16 February 2026

This letter responds to your comments made on behalf of Eastleigh Borough Council (EBC, dated 2nd October 2025) to the outline planning application O/25/99506 on Southampton Airport Navigator Quarter (herein referred to as the “Site”).

PROJECT: Southampton Airport - Navigator Quarter

MAP 1 Map of Reptile Corridor Area

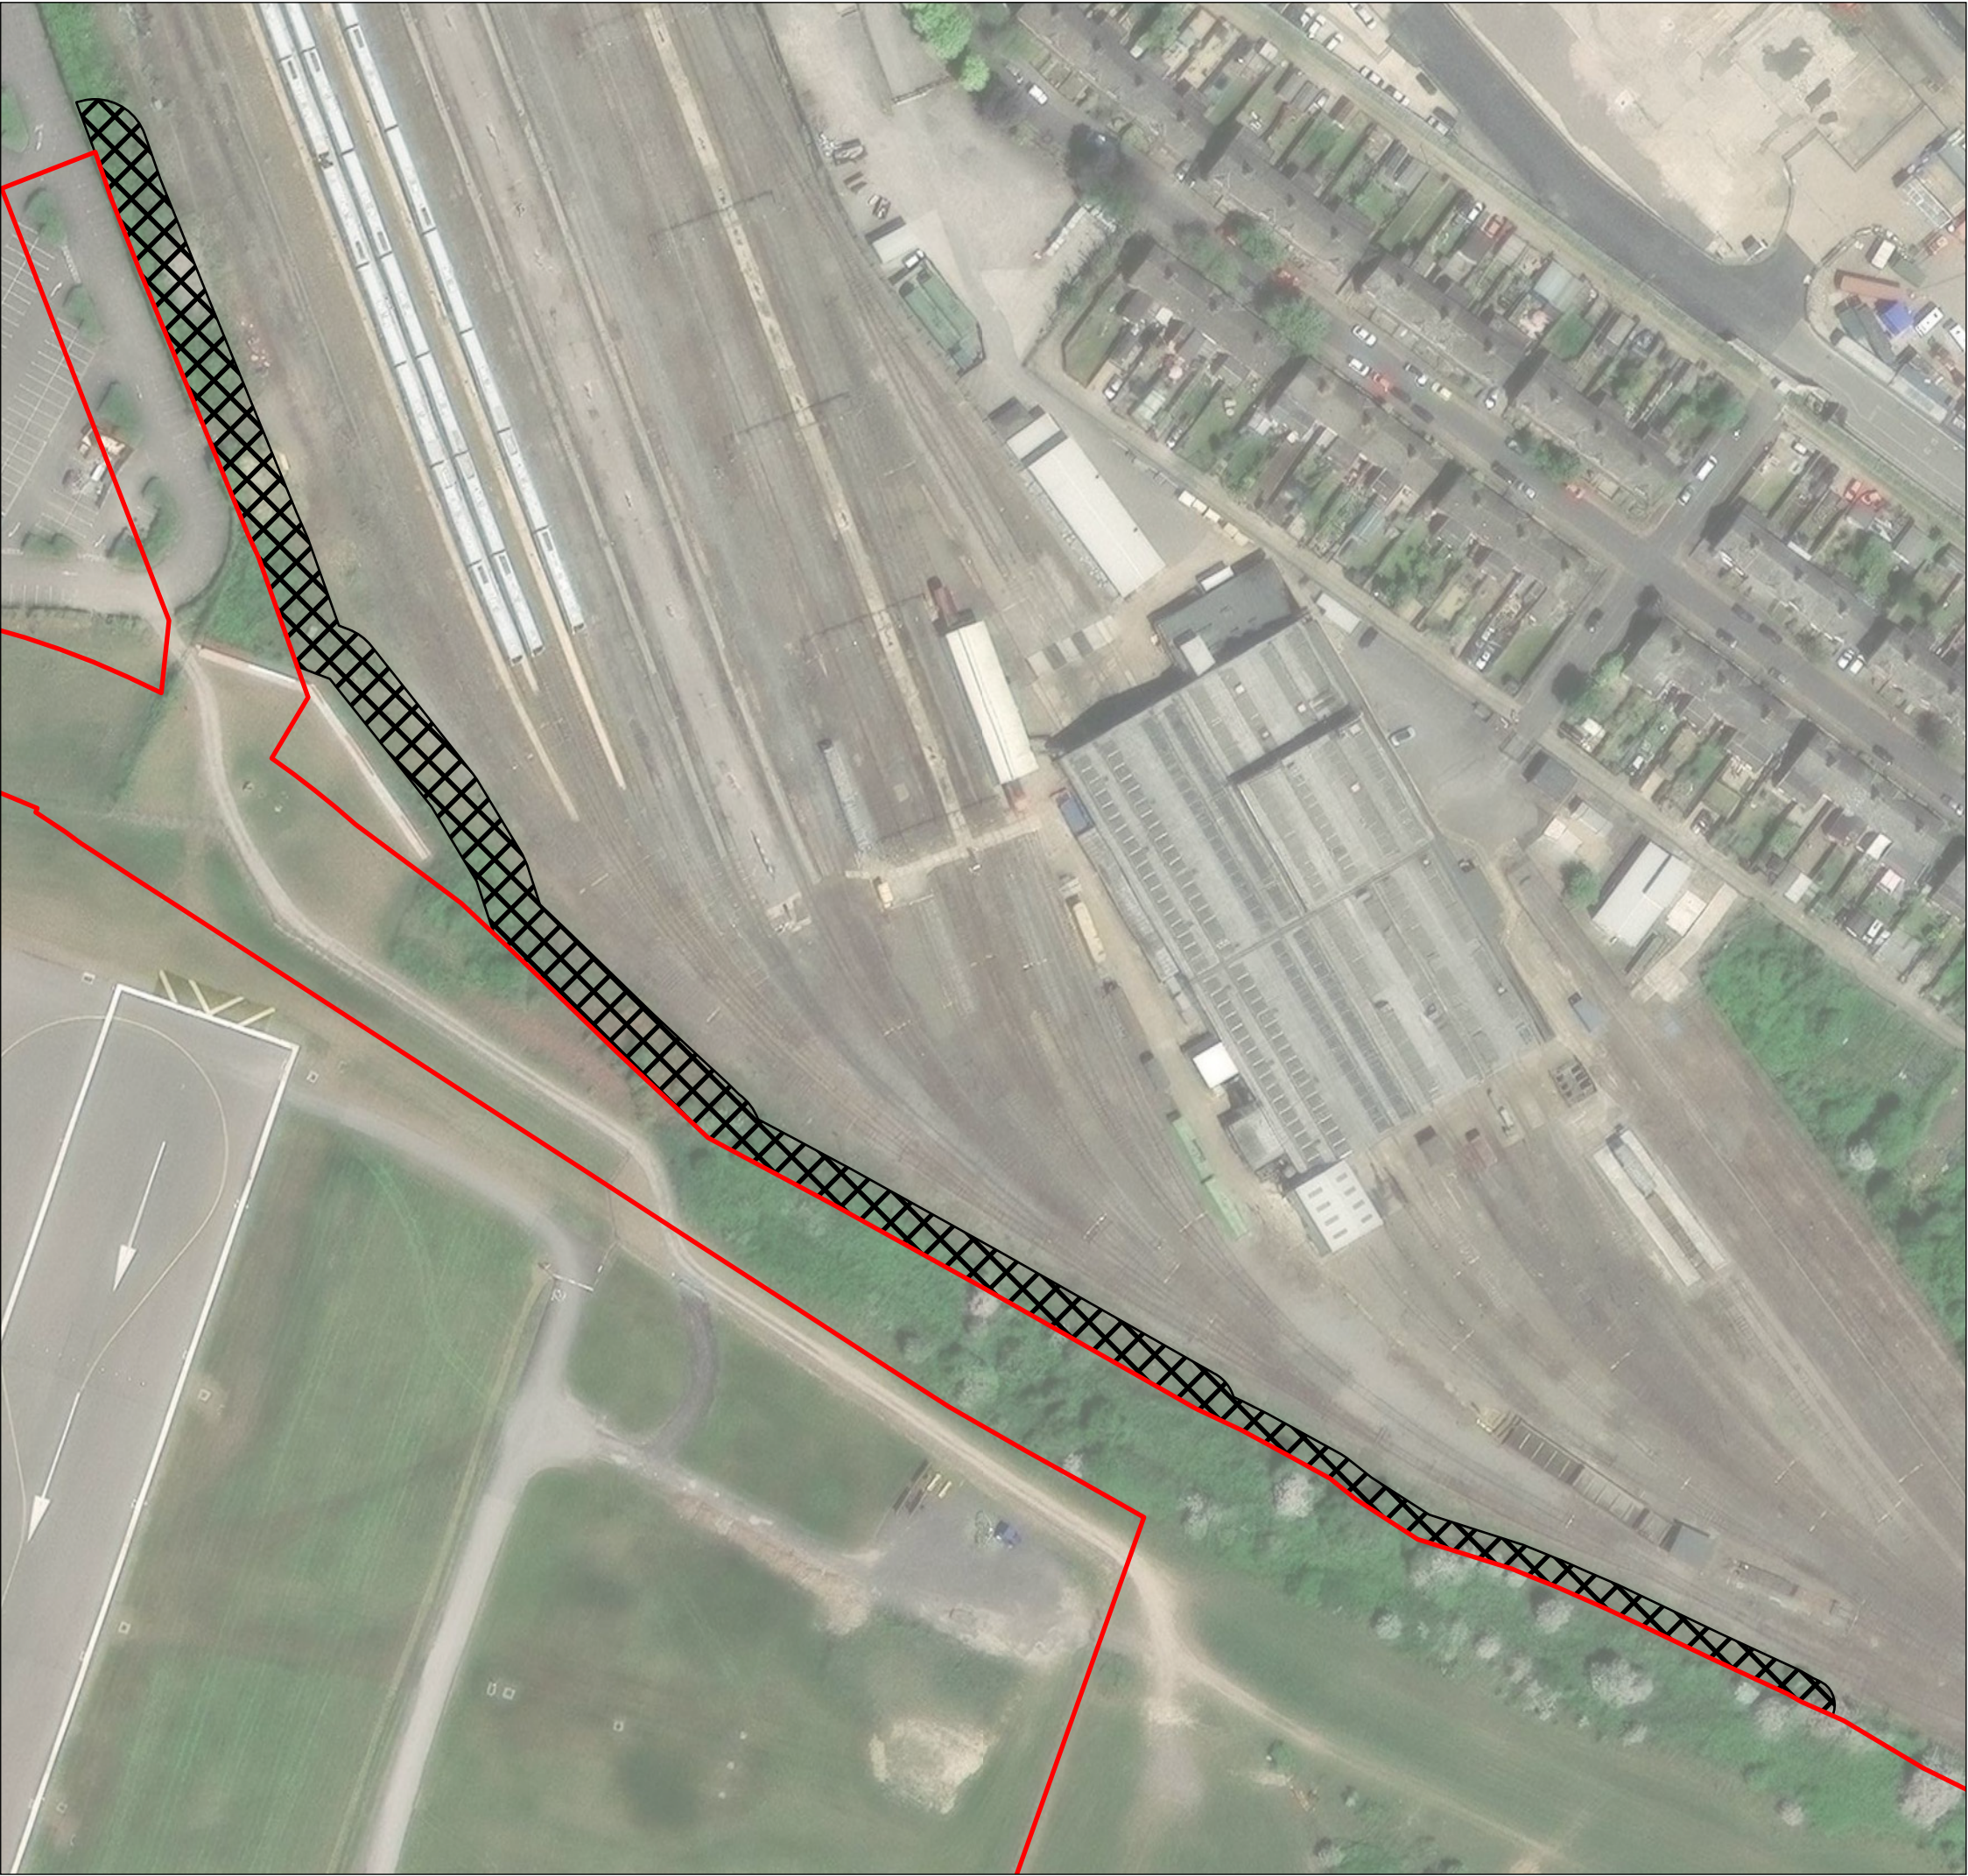
EBC raised concerns that the internal access road proposed along the northern boundary of the Site would result in a localised narrowing of the east–west reptile corridor, with the potential to reduce its ecological functionality. The alignment of this road is fixed due to engineering, operational and site layout constraints, and therefore cannot be modified to widen the buffer on the development side.

Discussions were undertaken with NR regarding the potential to utilise adjoining land to re-align and broaden the reptile corridor at this pinch-point. Through NR’s formal consultation process, it has subsequently been identified that the relevant parcel of land is subject to a long-term leasehold arrangement with a third-party freight operator. The Applicant is actively progressing discussions with NR and the relevant leaseholder to secure the delivery of the reptile mitigation corridor shown on Map 1, which has been identified as the appropriate and proportionate solution to address the localised constraint at this location. However, the land is not currently available to be relied upon as part of the mitigation package for the purposes of determination, and no reptile mitigation measures have yet been secured on land outside the Applicant’s control.

The Applicant will seek to enable the delivery of an off-site reptile corridor of approximately 0.38 hectares, providing a minimum corridor width of circa 10 metres at the pinch-point, widening on either side where space allows, and linking with reinstated reptile habitat within the Site. If and when secured, this would deliver a resilient and functional east–west connection through enhanced ecological connectivity, habitat structure and refugia provision.

While agreement with the leaseholder is not yet finalised, the Applicant remains committed to seeking to secure this mitigation and continues to engage constructively with the landowner. The mitigation strategy is clearly defined within the application documentation and identifies how habitat connectivity can be achieved, including through land north of the Site should agreement be secured. The application is therefore presented and should be determined in the context of the land not currently being within the Applicant's control.
